UNITED STATES  
NUCLEAR REGULATORY COMMISSION  
WASHINGTON, D.C. 20555-0001

LICENSEE: Commonwealth Edison Company  
FACILITY: Quad Cities Nuclear Power Station, Units 1 and 2  
SUBJECT: SUMMARY OF MEETING CONCERNING THE PROCESS OF RESOLVING  
APPENDIX R ISSUES AT QUAD CITIES NUCLEAR POWER STATION

QUAD CITIES APPENDIX R (FIRE PROTECTION)  
MEETING - SEPTEMBER 10, 1998

Figure 1  
SSA Optimization Flowchart

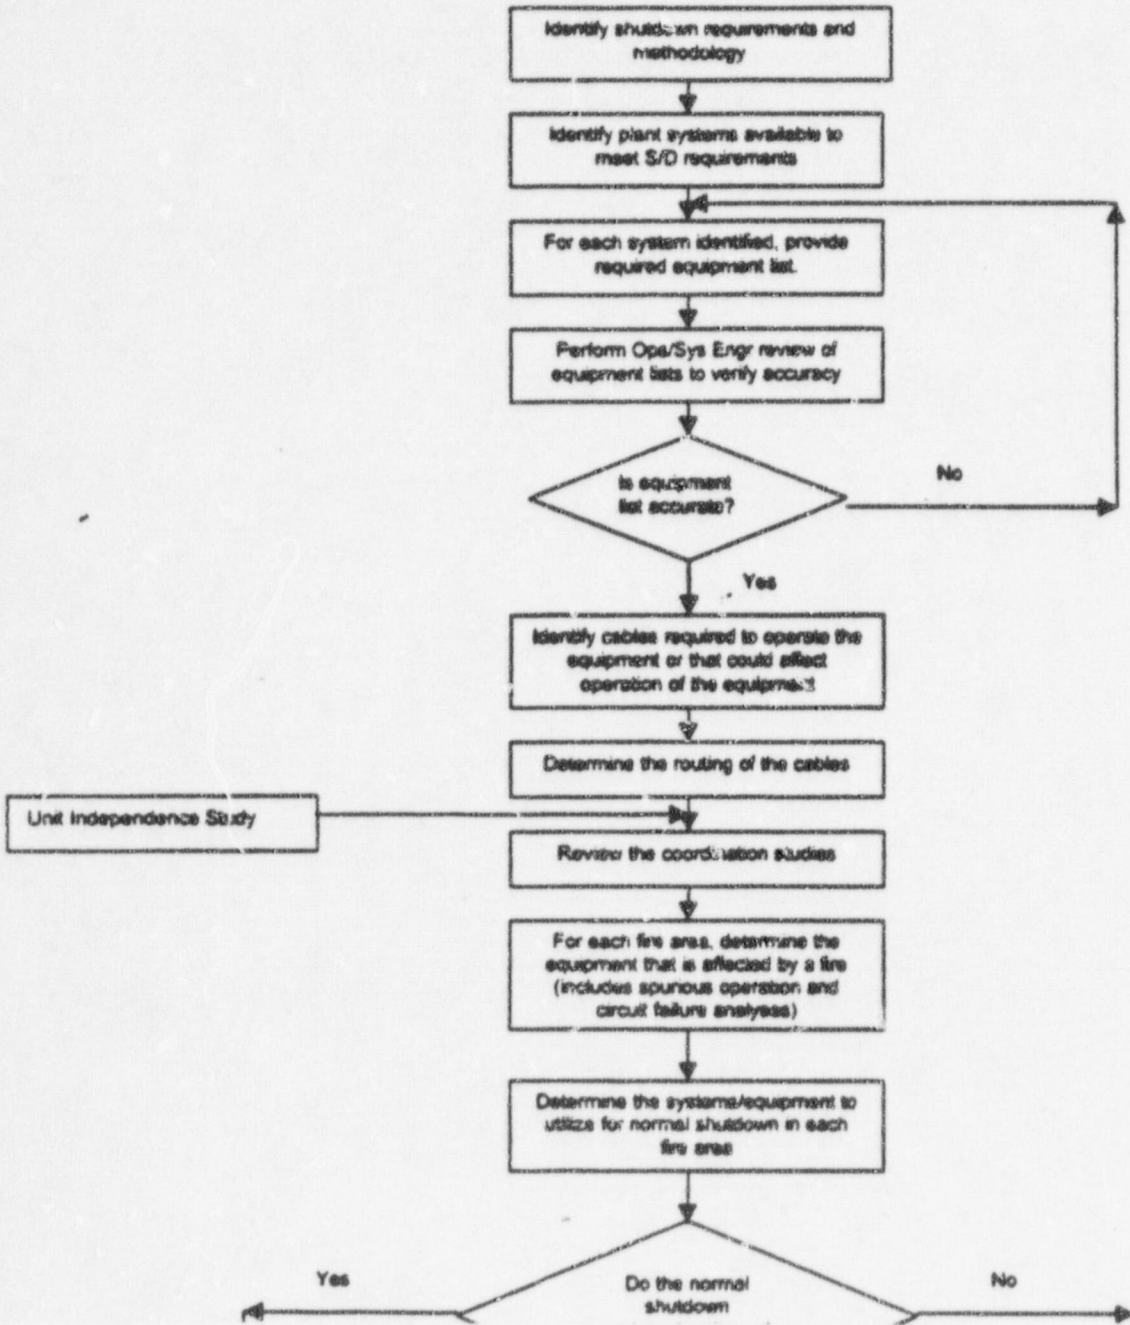
The licensee indicated that they are on schedule with this evaluation and that it will be completed in December 1998. The staff stated that the process outlined in Figure 1, "SSA [Safe Shutdown Analysis] Optimization Flowchart" (Enclosure 3) was an acceptable approach to improve fire protection and the post-fire safe shutdown capability at Quad Cities. The licensee stated that the objective of the evaluation was to reduce manual actions and not abandon the control room and to make the station emergency diesel generators as the primary electrical source during a fire.
